# DRI REGIONAL REVIEW FINDING

**RE:** Development of Regional Impact (DRI) Review

Name of Proposal: Douglas Waldrop DRI 4192
Submitting Local Government: Douglas County

<u>Description</u>: A DRI review of a proposal to construct a data center with 1,760,850 million SF of space in 2 buildings with associated support facilities on a 166-acre site at 2912 Post Road in Douglas County.

PROJECT NO. **CONCEPT SITE**

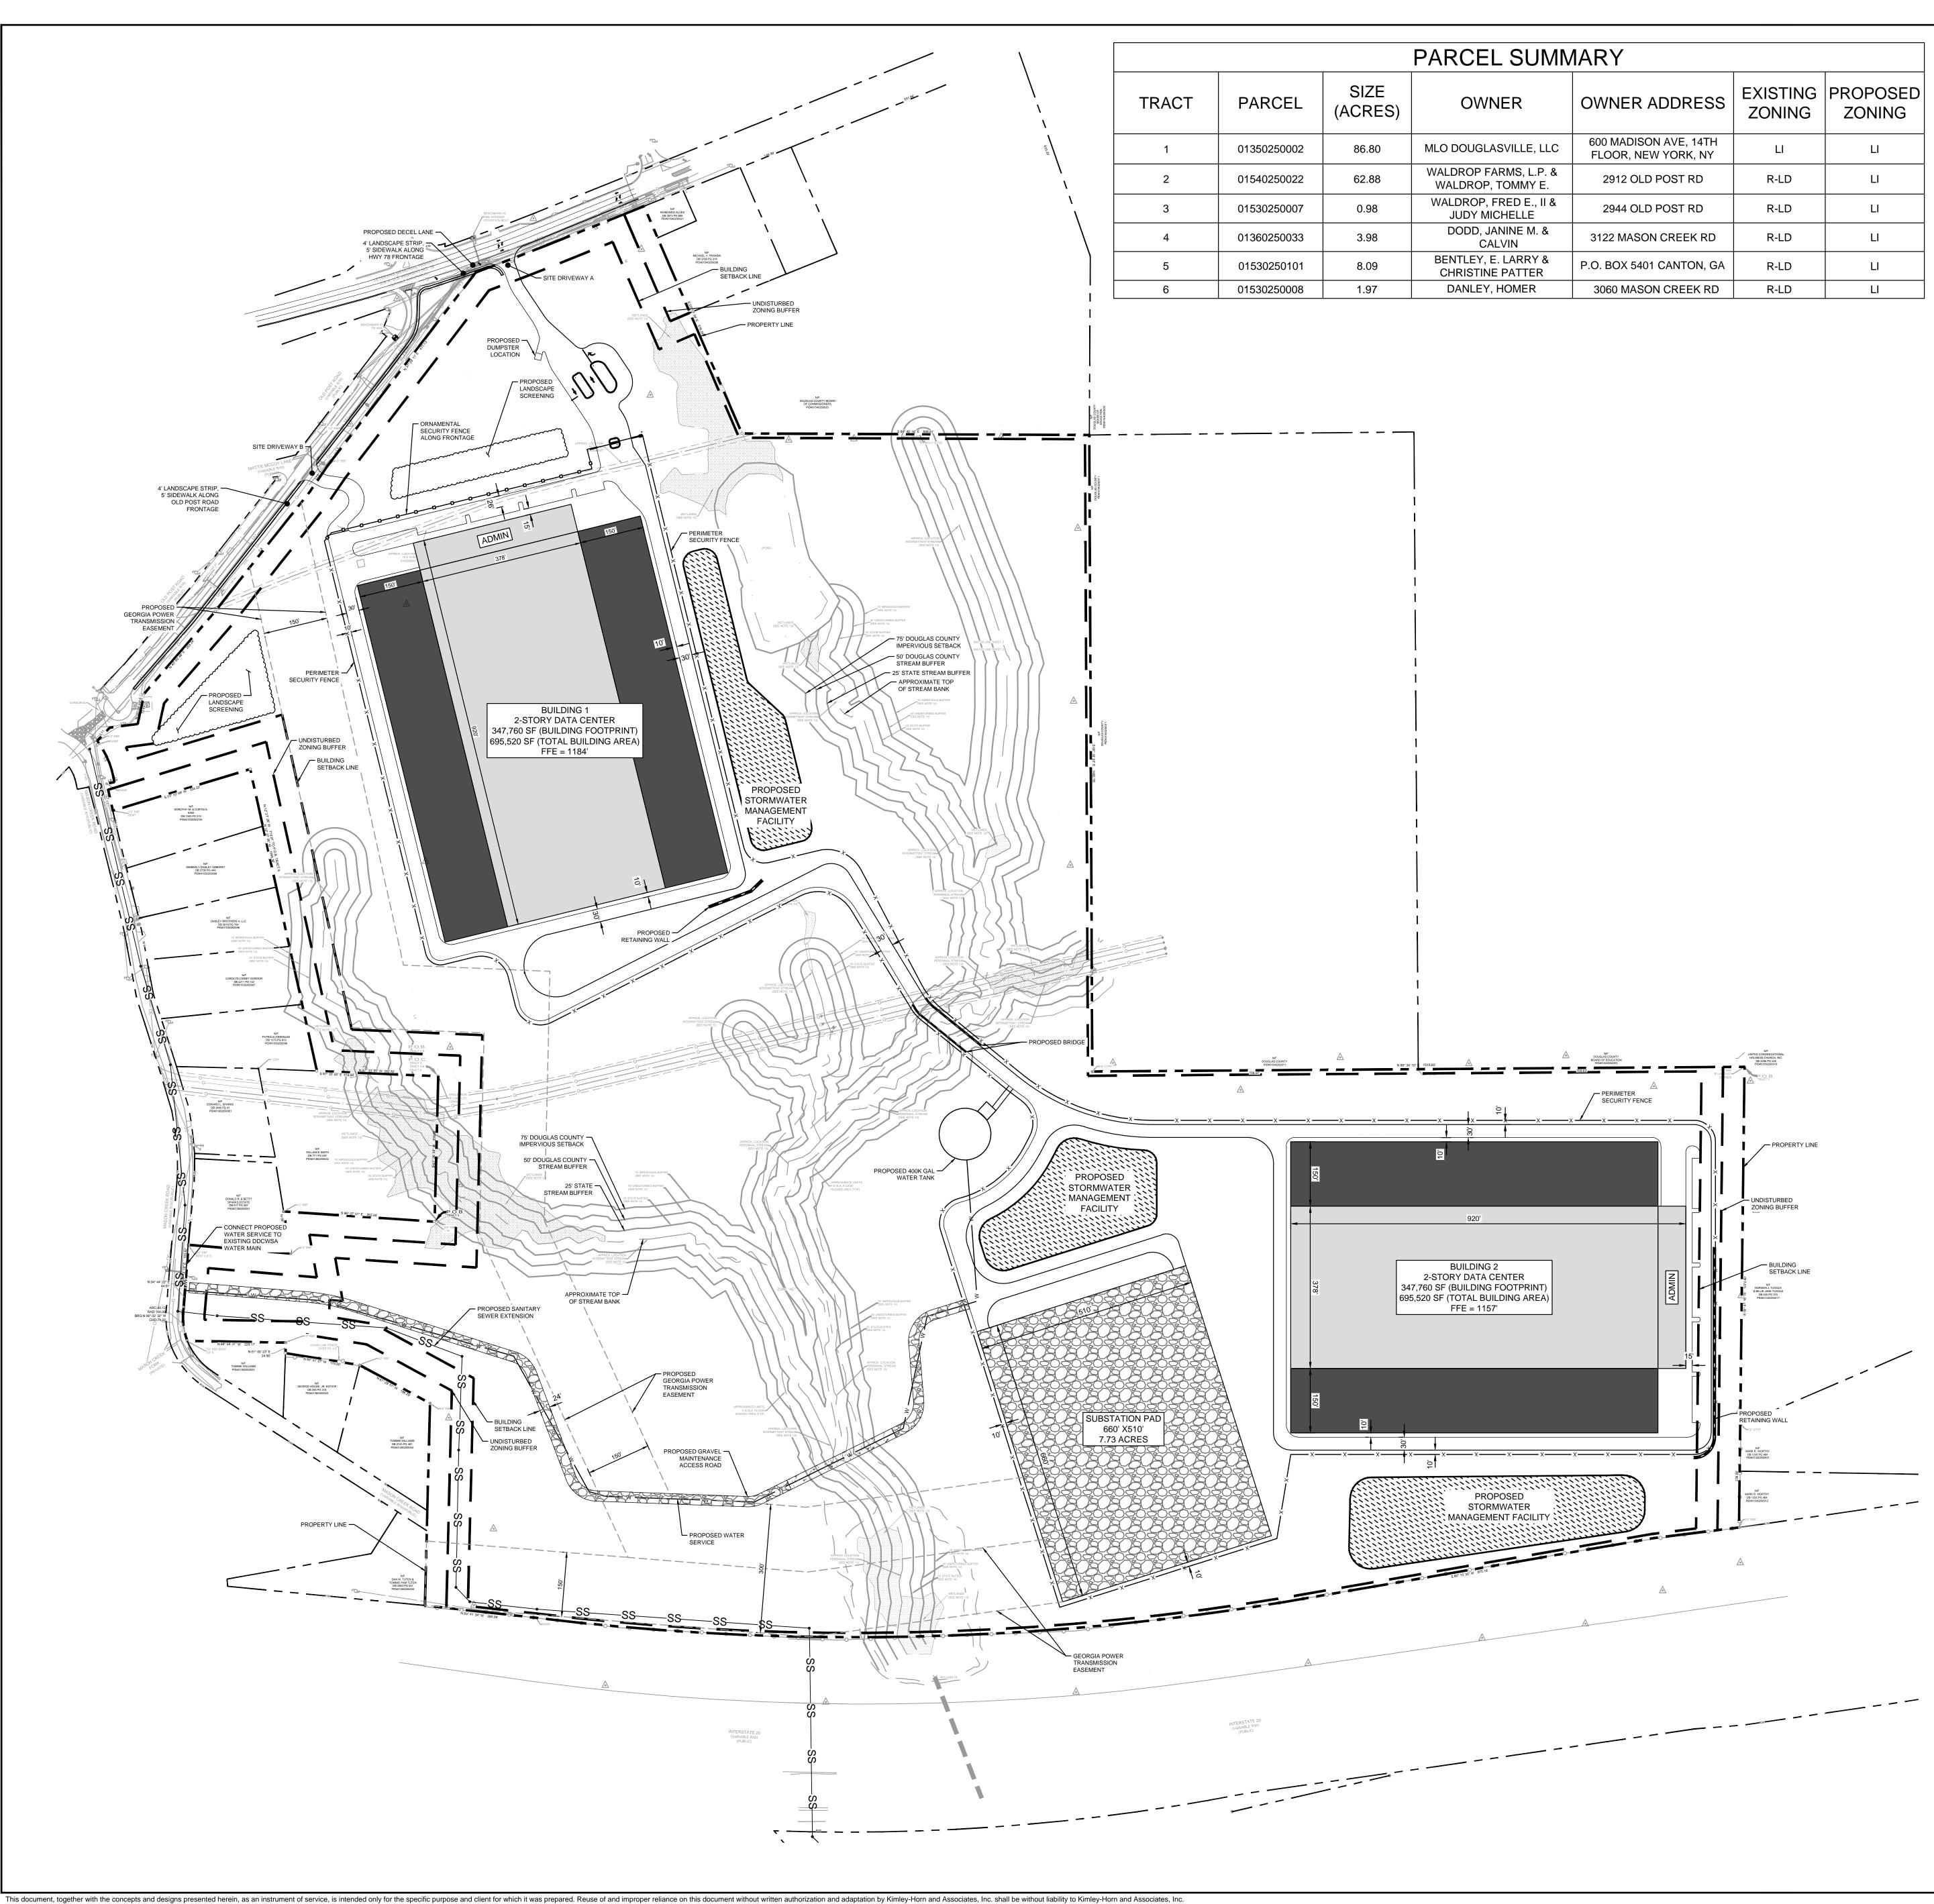
The USGS coverage for the project area and the submitted site plan both show a blue-line tributary of Mobley Creek starting at the existing pond on the property and running south through the property. The submitted site plan shows a short segment of an unmapped stream flowing into the mapped tributary. The submitted conceptual site plan shows and identifies the 25-foot State Sediment and Erosion Control Buffer as well as the County 50-foot undisturbed buffer and 75-foot impervious setback on both streams. The only intrusions into the buffers shown on the site plan are two road crossings, which are allowed under Section 9, Environmental Protection, of the County Unified Development Code.

The project is somewhat aligned with regional environmental policies in that it preserves some of the site as natural area. Stream buffer intrusions are proposed for two road bridges. It could be more aligned with these policies by creating a mechanism for conserving and maintaining the open space retained, utilizing a low-impact design and construction approach, and allocating some of the substantial local revenue generated toward natural area conservation and acquisition elsewhere in the County. The project can support The Atlanta Region's Plan by incorporating other green infrastructure and/or low-impact design,

The project is not aligned with Rural Areas policies due primarily to its large building and infrastructure footprints. It could be better algned with these policies by retaining additional open space, creating a mechanism for conserving and maintaining the open space retained, utilizing a low-impact design and construction approach, and allocating some of the substantial local revenue generated toward natural area conservation and acquisition elsewhere in the County.m The final design of the project could further the intent of the Rural Areas recommendations by utilizing rural character elements in the design of project roads, bridges, fences, and related components.
